## DEVIATION REQUEST AND DECISION FORM

Project Name :	Grandview Reserve
Schedule No.(s) :	
Legal Description :	<p>A TRACT OF LAND BEING PORTIONS OF THE SOUTH HALF OF SECTION 21, SOUTH HALF OF SECTION 22, NORTH HALF OF SECTION 28 AND SECTION 27, TOWNSHIP 12 SOUTH, RANGE 64 WEST OF THE SIXTH PRINCIPAL MERIDIAN, EL PASO COUNTY, COLORADO, BEING DESCRIBED AS FOLLOWS:</p> <p>BASIS OF BEARINGS: THE EAST LINE OF SECTION 21, BEING MONUMENTED AT THE SOUTHEAST CORNER BY A 3-1/4" ALUMINUM SURVEYOR'S CAP STAMPED "PS INC PLS 30087 1996", BEING APPROPRIATELY MARKED, AND BEING MONUMENTED AT THE NORTHEAST CORNER BY A 3-1/4" ALUMINUM SURVEYOR'S CAP STAMPED "PS INC PLS 30087 1996", BEING APPROPRIATELY MARKED, BEING ASSUMED TO BEAR NORTH 00 DEGREES 52 MINUTES 26 SECONDS WEST, A DISTANCE OF 5290.17 FEET.</p> <p>COMMENCING AT THE SOUTHEAST CORNER OF SAID SECTION 21; THENCE NORTH 00 DEGREES 52 MINUTES 26 SECONDS WEST ON THE EAST LINE OF SAID SECTION, A DISTANCE OF 2645.09 FEET TO THE NORTHEAST CORNER OF THE SOUTHEAST QUARTER OF SAID SECTION 21, SAID POINT BEING THE POINT OF BEGINNING; THENCE NORTH 89 DEGREES 41 MINUTES 03 SECONDS EAST ON THE NORTH LINE OF THE SOUTH HALF OF SAID SECTION 22, A DISTANCE OF

Figure 1- Proposed Cross Section for MST

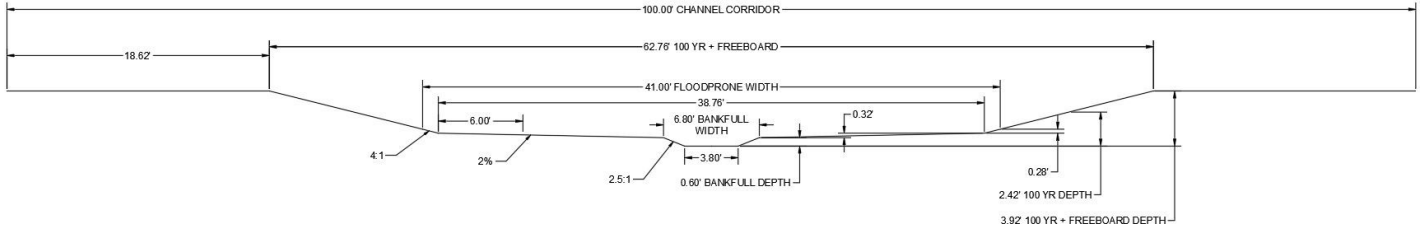
R6: Deviation not needed for low-flow capacity any now, but is for bottom width.

Address bottom width.

Address bottom width.

The following parameters shall be used for the design.
